ADDENDA – A-01

.1 Bids in accordance with the Drawings and Specifications included with these Bid Documents for:
Fort St. John Hospital – Residential Care Cooling Upgrade.

PROJECT:
**FORT ST. JOHN HOSPITAL
RESIDENTIAL CARE COOLING
UPGRADE**

FILENAME: P:\220044 - FSI\44 Res Care Cooling Upgrade\DWG\E100 - Building A - Levels 0A and 1.dwg
PLOT DATE: 2023-12-28 10:01

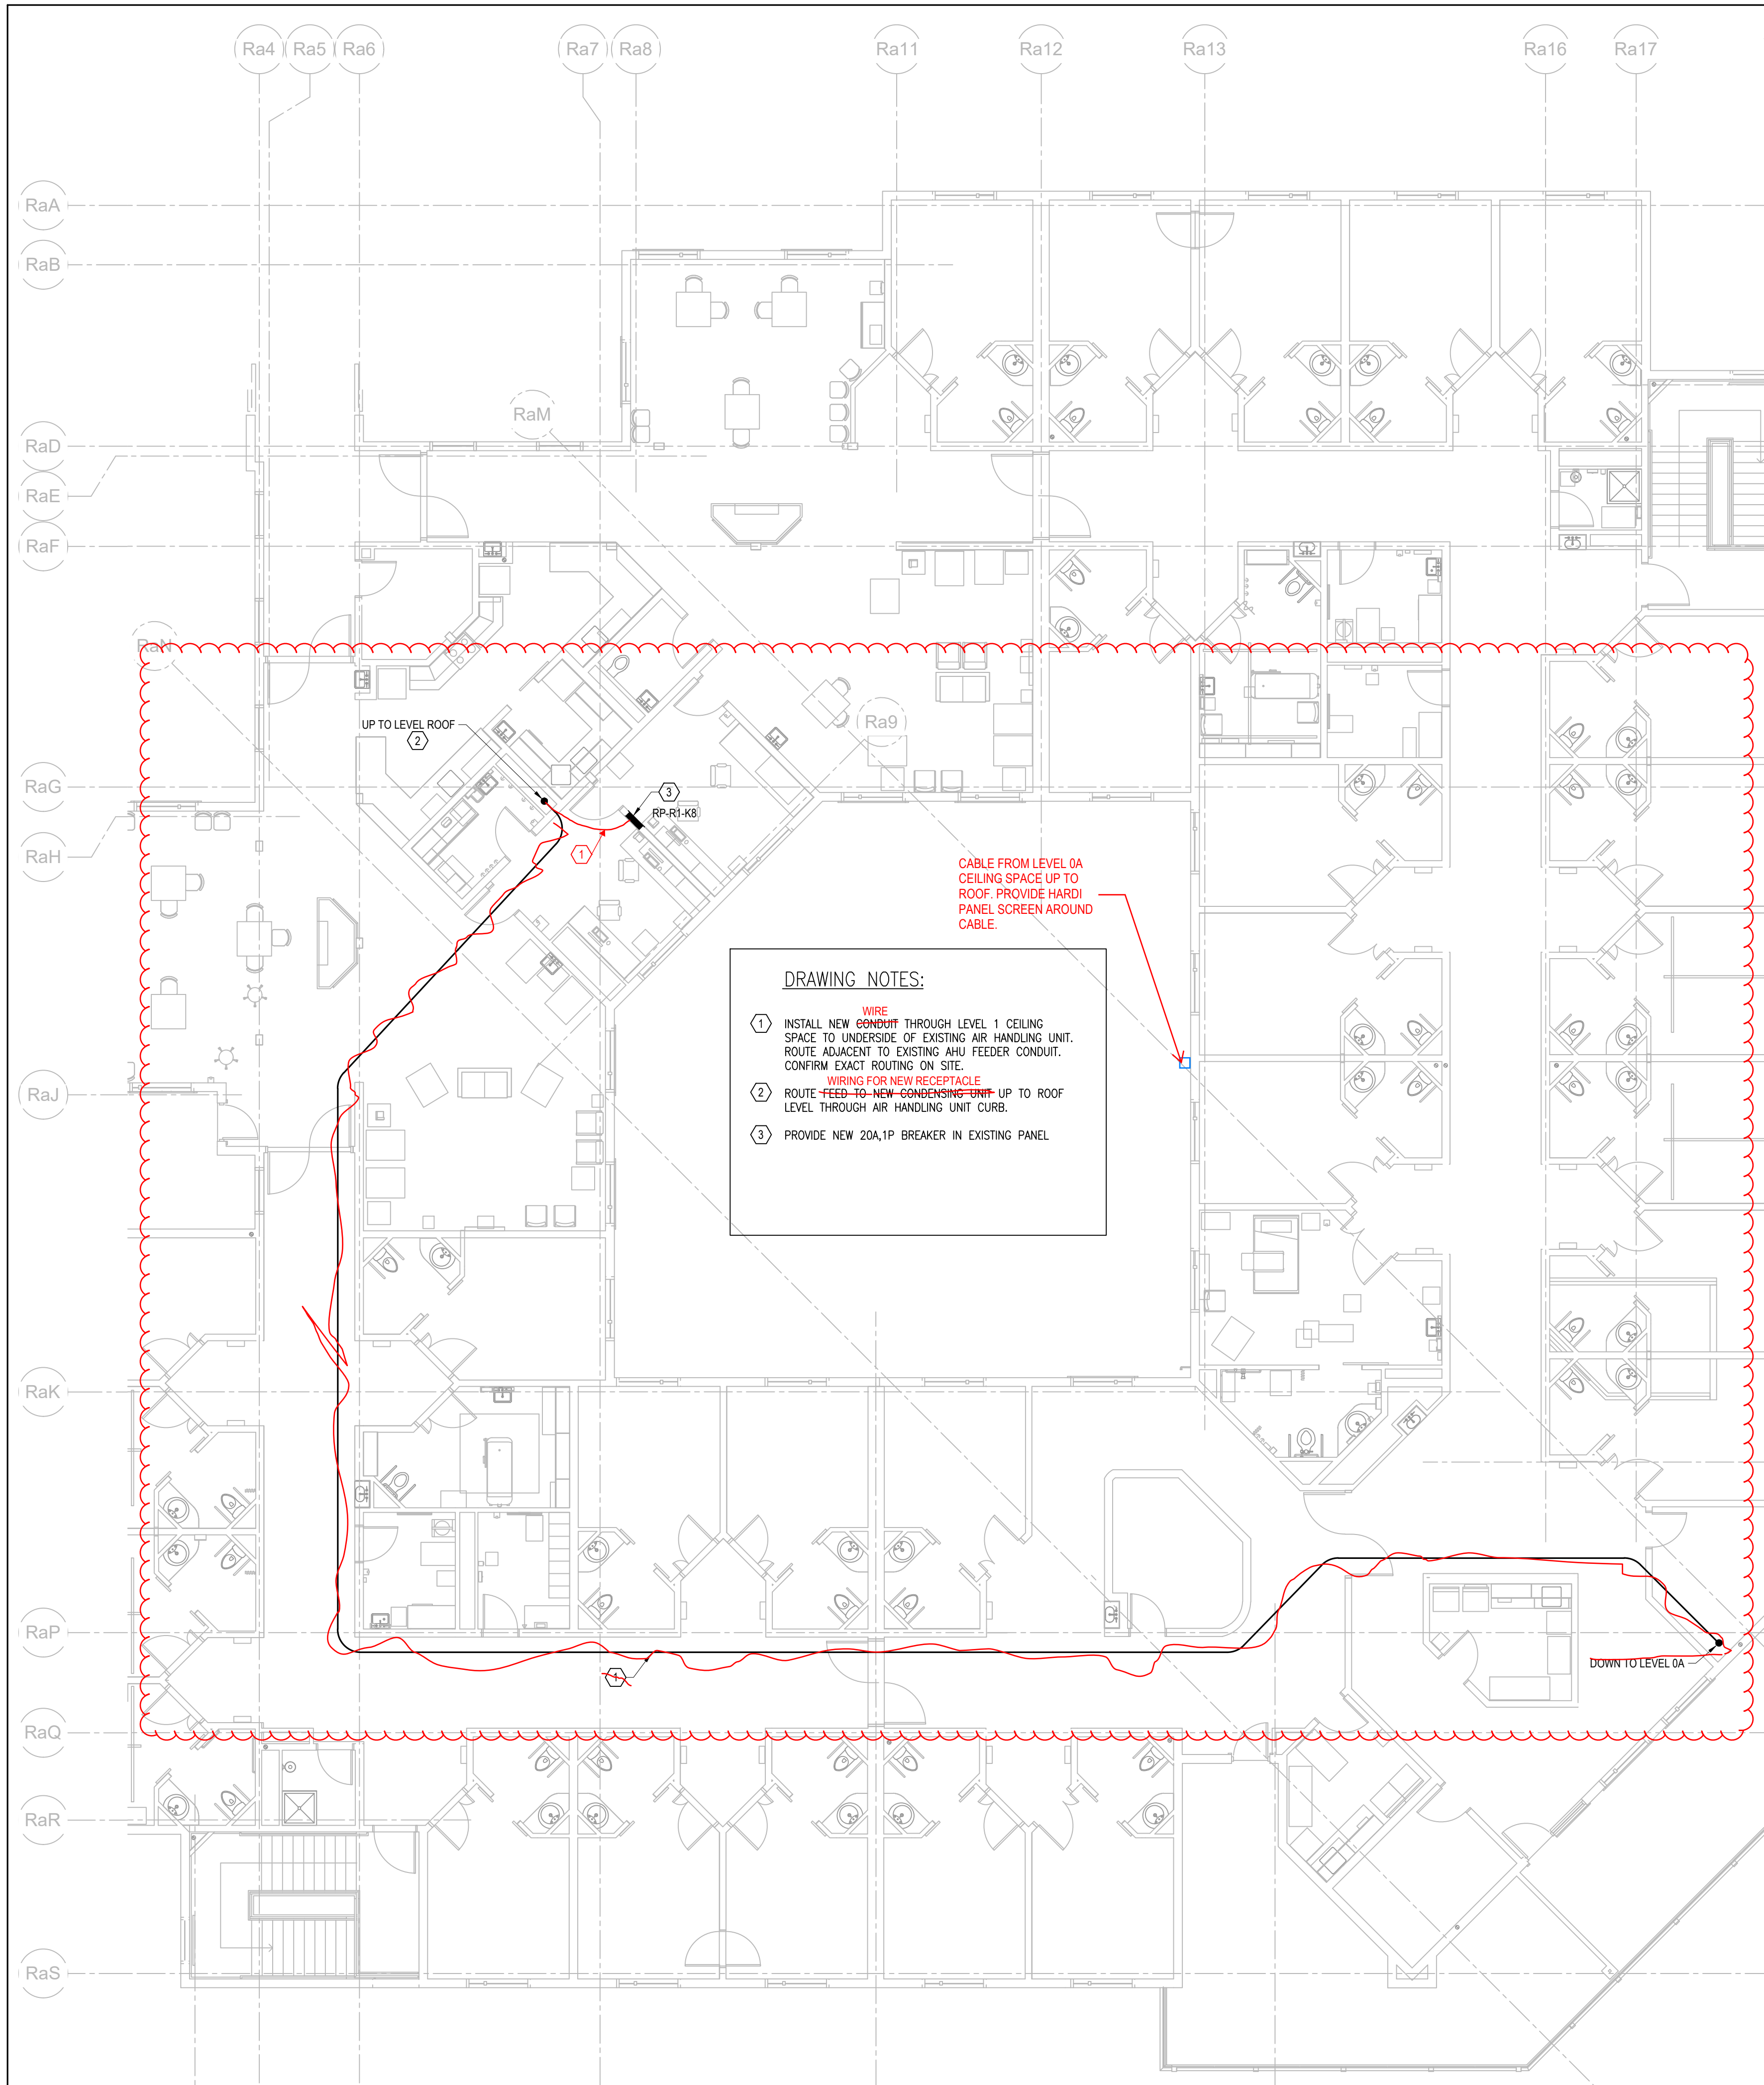
2.1 SK – CURB AT ROOF

.1 Add sketch “SK - Curb at Roof”

DRAWING TITLE:
**ELECTRICAL PART PLANS
HOUSE A
LEVELS 0A, 1, & ROOF**

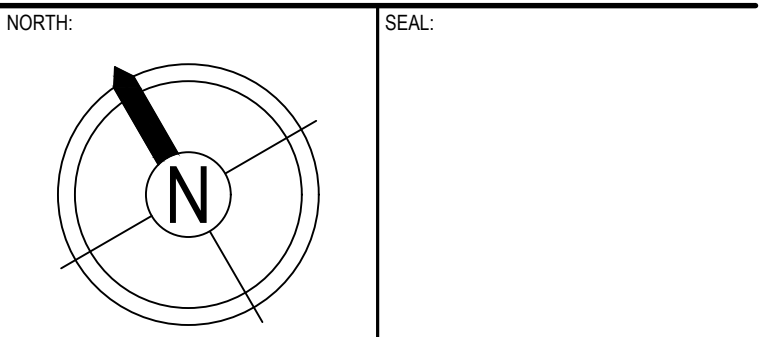
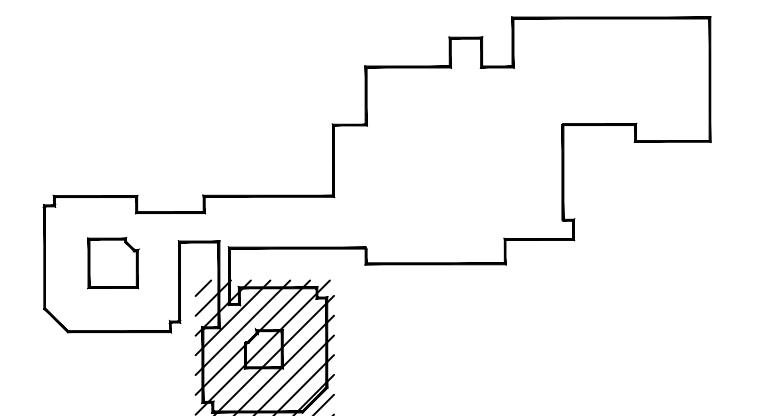
2.4 E100 – ELECTRICAL PART PLANS HOUSE A LEVELS 0A, 1, & ROOF

.1 Revised approach to new wiring approach as shown.

3 ELECTRICAL FEEDER ROUTING**3.1 Description of Revised Approach**

- .1 The electrical feeder routing to the new condenser units in House A and House B has been revised to route exterior to the building, refer to the updated electrical drawings.
- .2 Exterior electrical feeders to be rated for outdoor installation and extreme environments, see “TECK90 – Aluminum Conductor” product datasheet included.
- .3 Exterior electrical feeders to be in an enclosure fastened securely to the building with Hardi plank finishing to match the building and minimize visual impact.
- .4 Electrical feeders shall not be exposed in the courtyard or accessible to patients or visitors in any way.
